SERVICE BULLETIN

Model: **450-1000 kW (Detroit Diesel Series 2000 Engines) with DDEC**

Subject: **Overcrank Fault Shutdown and Hard Starting Troubleshooting**

Figure 1 Fuel Vent Line Service Kit GM32657-KP1 Components

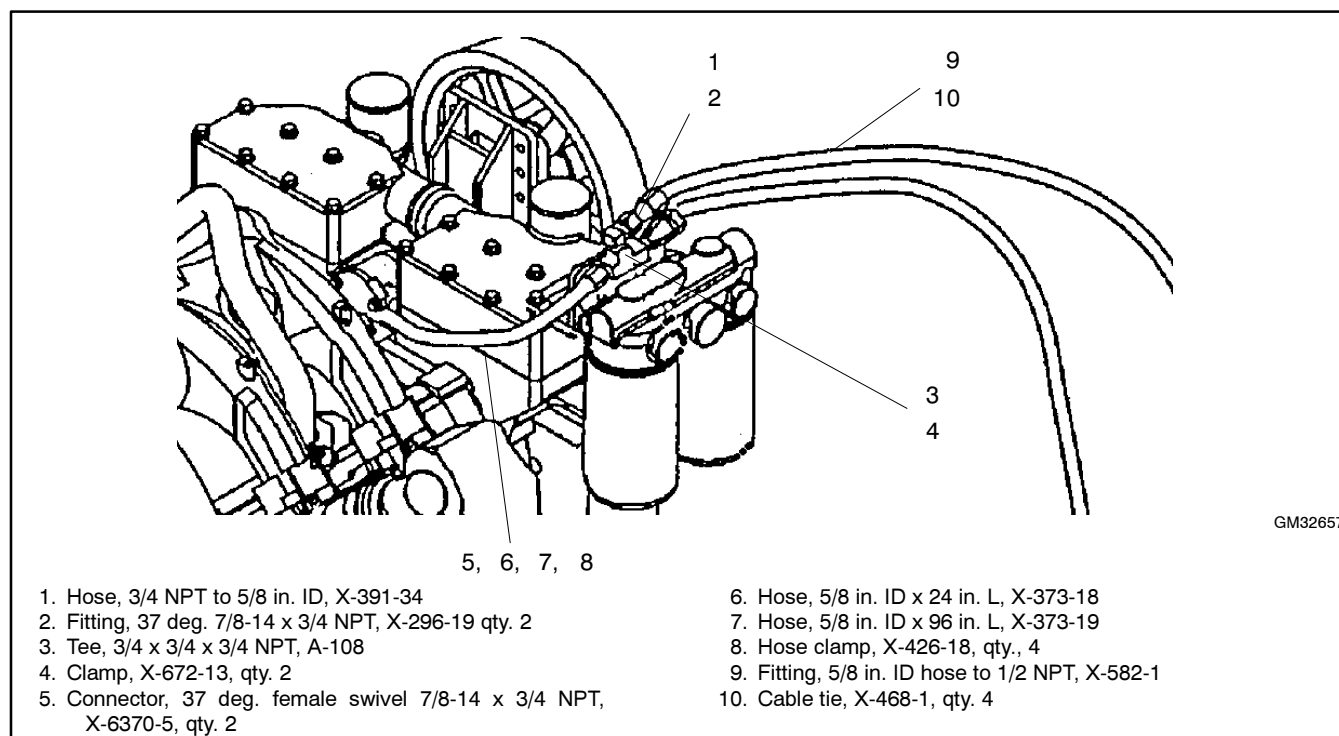
Add a vent line to the fuel return line. Available as Fuel Vent Line Service Kit GM32657-KP1. See Figure 1 for kit components and Figure 2 for fuel tank connection recommendations. The installer must use care in routing the supplemental vent line to prevent low spots which could trap fuel and inhibit venting.

Figure 2 Fuel Tank Connections and Recommendations

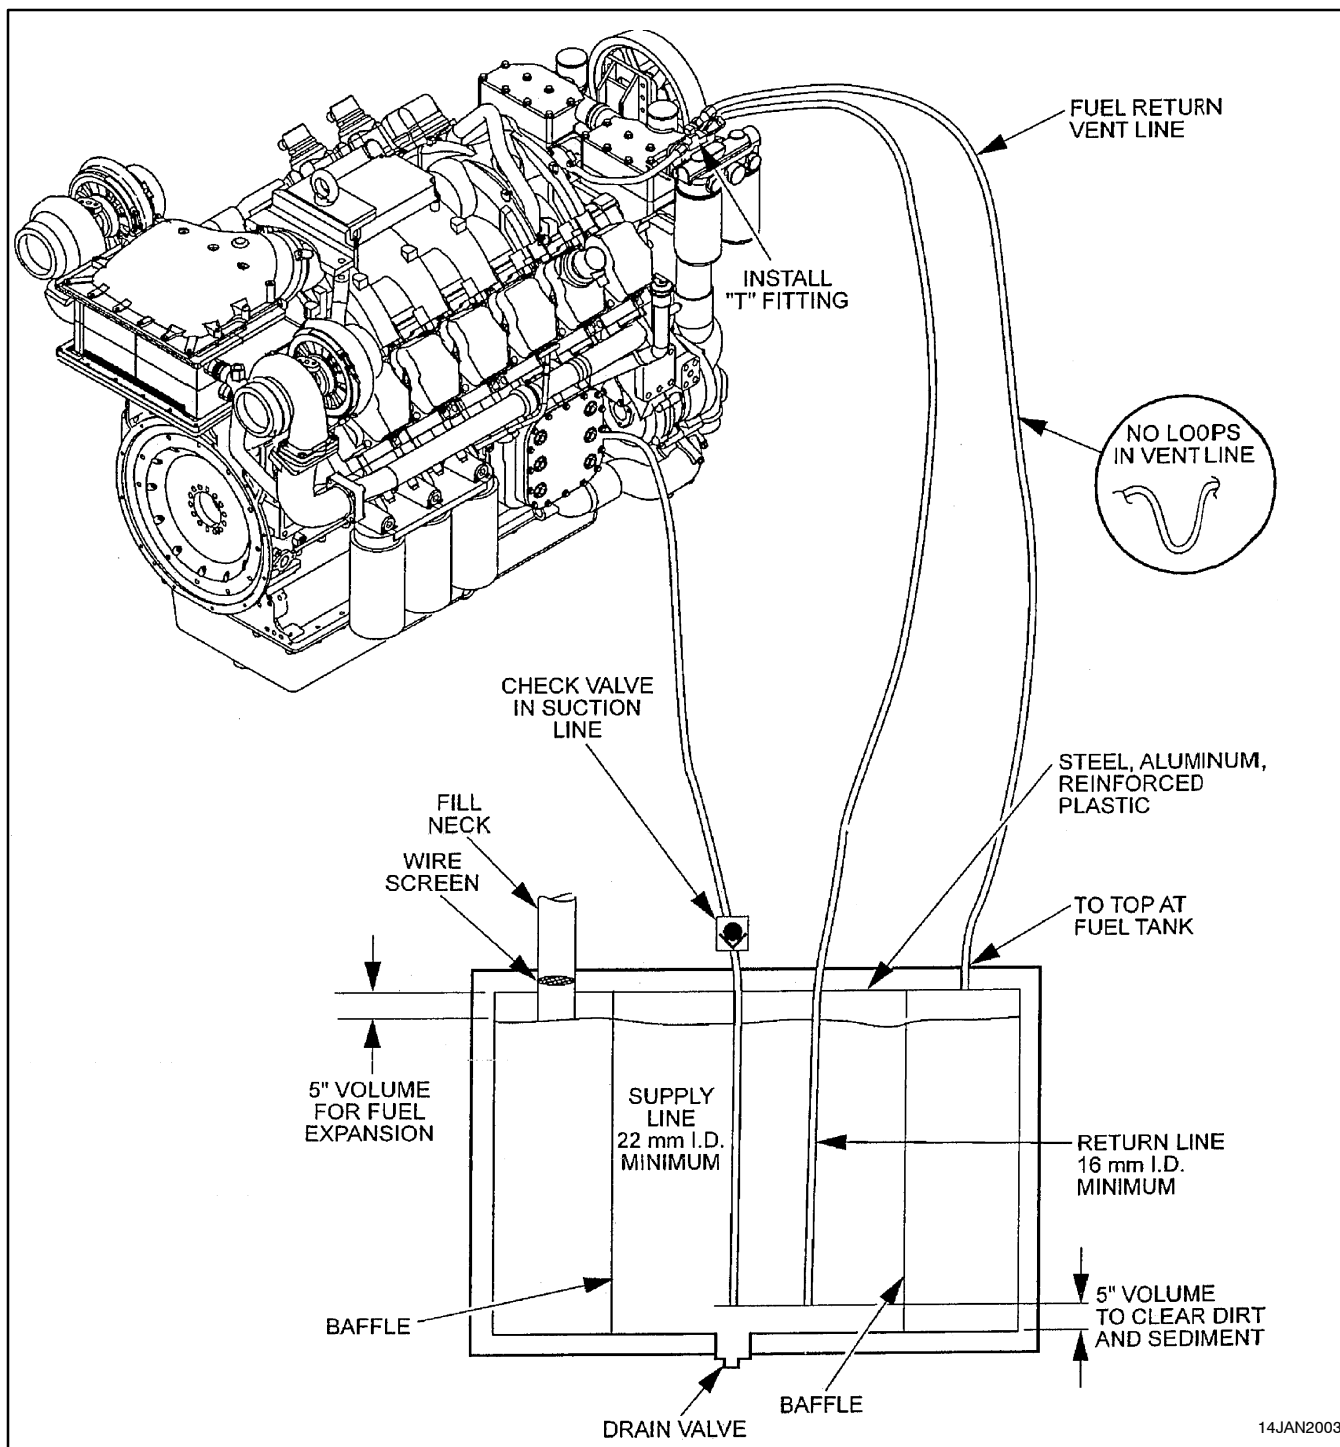
Prevent the fuel drain back condition by installing a check valve in the fuel supply line between the primary filter inlet and the fuel tank. Match the check valve size to the fuel supply line size and maximum fuel flow. Locate the check valve as close as practical to the fuel

tank to provide maximum positive head pressure on the check valve promoting effective check valve sealing.
